33522B-02

# Modification Recommended Service Note

## 33522B Function Generator

Serial Numbers: MY000000000 to MY57800600 and SG000000000 to SG57800600

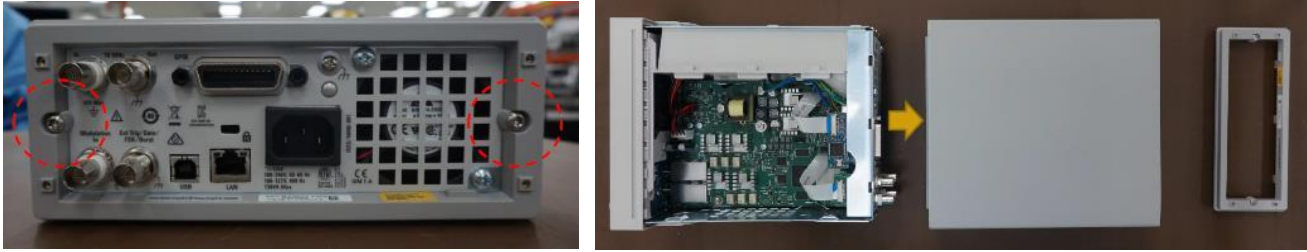
**The Problem** – Some customers have reported that, when line power is applied to the instrument but the instrument is NOT turned on (“Standby Mode”), some instruments will emit an audible high-pitched whistle or whine. To fix this, the existing power supply must be replaced with a newly designed power supply, as detailed in the solution below.

The solution is to replace the old power supply with a new one. The old power supply was manufactured by XP Power. The new power supply is manufactured by MeanWell, and has Part Number 0950-6082.

**Old Noisy XP Power Supply (PN xxxx-xxxx)**

**New MeanWell Power Supply (PN 0950-6082)**
